STAFF REPORT

REFERENCE: RM080373 (Subdivision) and RM080374 (Land Use) RM080361 (Water course crossing/S13 of the RMA)

SUBJECT: **C TUFFNELL - REPORT EP09/01/04** - Report prepared for hearing of 26 January 2009

APPENDIX 1
Aerial photograph of site, ridgeline and indicative reserves

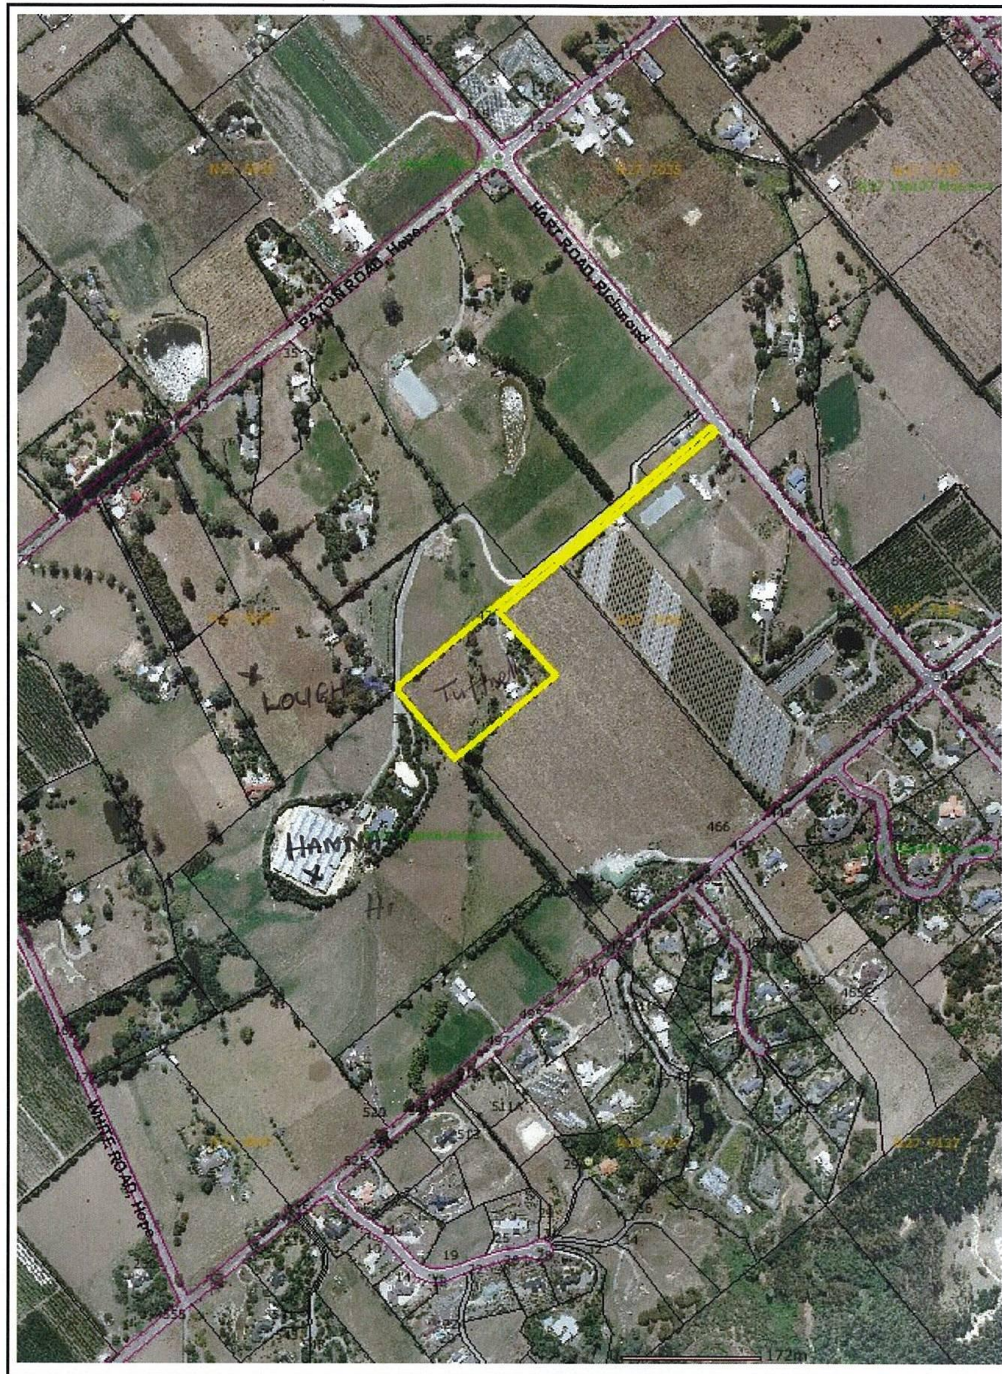
Rosalind Squire, the Council’s Reserves Planner has considered the proposal and in her report attached as **Appendix 4** emphasizes the importance of the indicative reserve shown on attached **Appendix 1** (10 metres recreation reserve and 15.2 metres of drainage reserve) being vested with Council at the time of this subdivision. The controlled standards contained within Rule 16.3.5.1(k) clearly articulates the TRMP expectation that Indicative Reserve Areas are to be vested in the Council as Local Purpose Reserve (walkway/recreation) and Local Purpose Reserve (drainage) at the time of subdivision. The significance of this matter is discussed more fully in Ms Squire’s report. Should the subdivision consent be approved conditions requiring the vesting these reserves have been included.

Figure 2 – Location and extent of the greenway on the applicants property

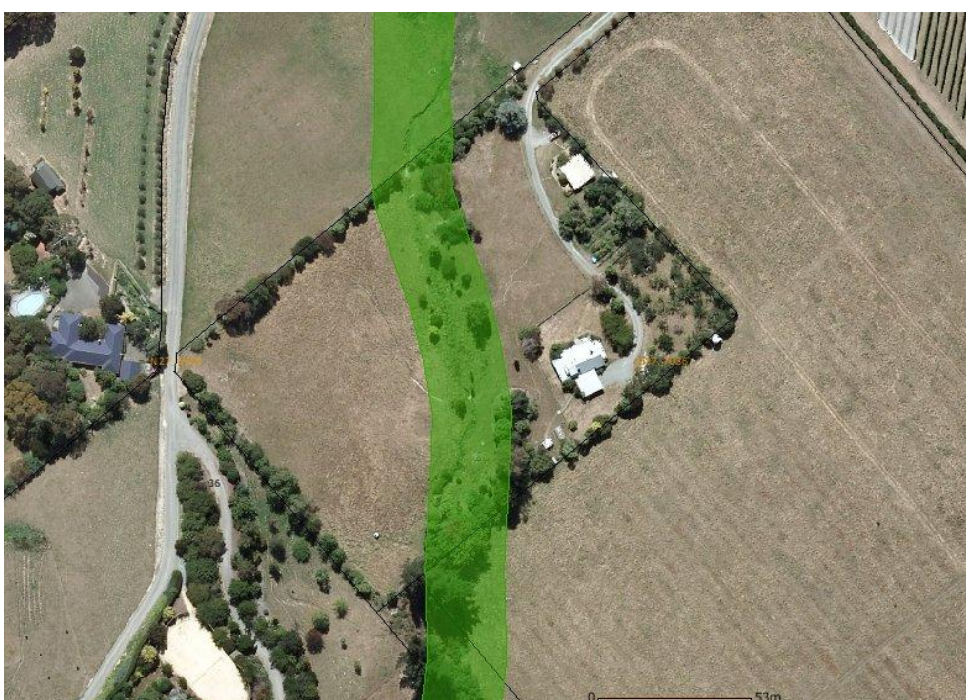
The controlled activity rule for subdivisions in both the Residential, Rural 1 and Rural 2 zones requires that land which is the subject to an indicative reserve notation on the planning maps to be set aside and vested in Council upon subdivision. The rule states that reserve areas are to be vested in Council as Local Purpose (walkway/recreation) and Local Purpose reserve (drainage) with the land being vested as Local Purpose Reserve (walkway/recreation) forming part of the financial contribution for reserves and community services in accordance with Rule 16.5.2.4.

The vesting of the indicative reserves on subdivision is also required in the corresponding discretionary rule in the Residential, Rural 1 and Rural 2 zones.

The rationale for requiring the vesting of the land at this point in time is that it is uncertain when or if the land will be further subdivided. The plan rules envisage that the land will be vested on subdivision at the earliest opportunity in order for all the links in the greenway network to be made as and when the opportunity arises.

1. The land shown as indicative reserve in the Tasman Resource management Plan shall be vested in the Tasman District Council as Local Purpose Reserve (Drainage) and Local Purpose Reserve (Walkway/Recreation). The drainage portion of the reserve shall be 15.2 metres in width and the two walkway/ recreation reserves on either side shall be 5 metres in width. The Local Purpose Reserve (Drainage) and (Walkway/Recreation) shall be shown as separate allotments on the scheme plan submitted for 223 approval.
2. In accordance with Rule 16.5.2.4 the area of land vested as Local Purpose Reserve (walkway/recreation) shall form part of the financial contribution for Reserves and Community Services.
